Access Compliance Report

Public Rights-of-Way

(Curb Ramps)

Intersection ID: 47754	Main Street: REBECCA_RUN_DR	Cross Street: BROCK_RN	Location:	E
ADA ID: 98F116DACAE0	Ramp Type: PerpDiag	Initial Pass/Fail: Fail	Overall Compliance: No	Severity Score: 22.5
Codes/Mitigation Info/Possible Solution		Field Measurements/Component Compliance

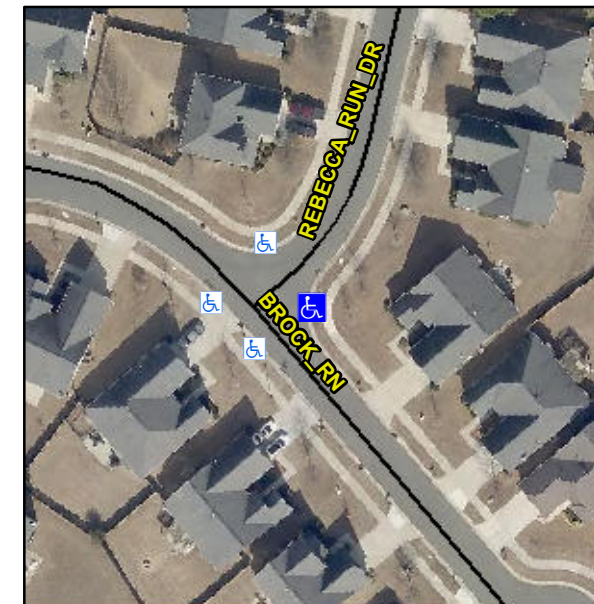
Not Found, R304.5.1, R304.2.2, R304.5.3

Compliance	Description	Data	Compliance	Description	Data
N/A	Ramp Length (in)	69.0	No	Ramp Slope (%)	8.4
No	Ramp Width (in)	45.0	No	Ramp XSlope (%)	3.1
N/A	Flare Type LT	N/A	N/A	Flare Type RT	N/A
N/A	Flare Slope LT (%)	N/A	N/A	Flare Slope RT (%)	N/A
N/A	Flare Traversable LT?	N/A	N/A	Flare Traversable RT?	N/A
N/A	Landing Length (in)	N/A	N/A	DWS Provided?	N/A
N/A	Landing Width (in)	N/A	N/A	DWS Contrast?	N/A
N/A	Landing Slope (%)	N/A	N/A	DWS Length (in)	N/A
N/A	Landing X Slope (%)	N/A	N/A	DWS Full Width?	N/A
N/A	Landing Curb? (Y/N)	N/A	N/A	DWS Offset (in)	N/A
N/A	Shared Landing?	N/A			
N/A	Gutter Ponding?	N/A	N/A	Gutter Slope (%)	N/A
N/A	Gutter Lip Ht (in)	2.0	N/A	Gutter X Slope (%)	N/A
N/A	Painted X Walk1?	No	N/A	Painted X Walk2?	No
	X Walk 1 Direction	To NW		X Walk 2 Direction	To SW
N/A	X Walk 1 Width (in)	N/A	N/A	X Walk 2 Width (in)	N/A
	X Walk 1 Slope (%)	1.8		X Walk 2 Slope (%)	1.2
	X Walk 1 X Slope (%)	0.8		X Walk 2 X Slope (%)	0.4

N/A	Ramp inside XWalk1?	N/A	N/A	Ramp inside XWalk2?	N/A
	Road Slope (%)	0.0	N/A	Clear Space?	N/A
	Road X Slope (%)	4.4	N/A	Clear Space to XWalk (in)	N/A
N/A	Any Obstructions?	N/A	N/A	Storm Grate/Utility Hazard?	N/A
	Obstruction Type			Storm Grate/Utility Type	
		N/A			N/A
			Yes	Surface Condition? (G/P)	Good

Remove & Replace Curb Ramp With Two New Directional Ramps or Equivalent.
